REPLACEMENT SYSTEM VARIANCE REQUEST

Town of Augusta

Permit No. 1652 E

System's Location: Young Rd, Togus Pond STREET

SUBSURFACE WASTEWATER DISPOSAL PLAN

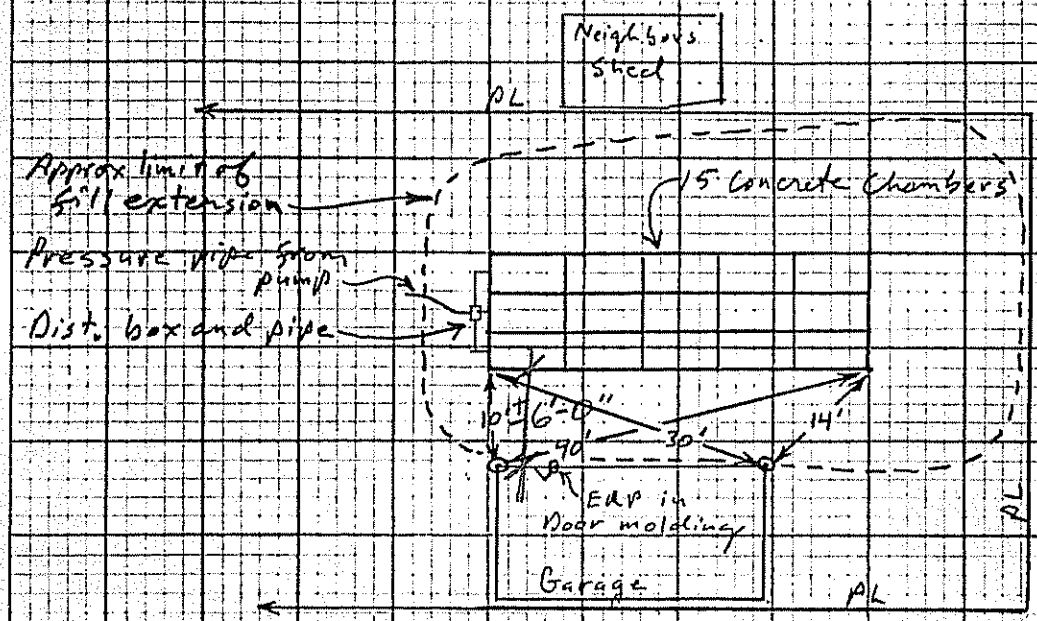
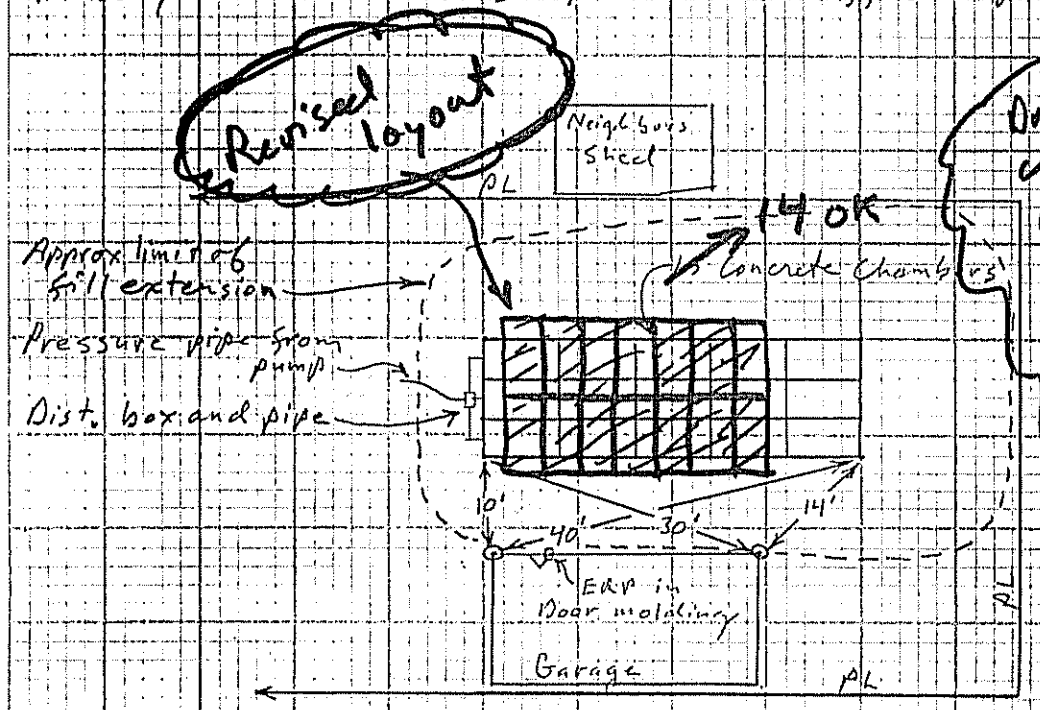
Drawing Revisions due to changes during const. Contractor ordered Side inlet chambers instead of end inlet as shown. Change is acceptable provided
- Footprint remains essentially the same
- minimum grades maximum grades are acheived.
- State variance for < 10' to garage is obtained.
- Construction elevations are not changed
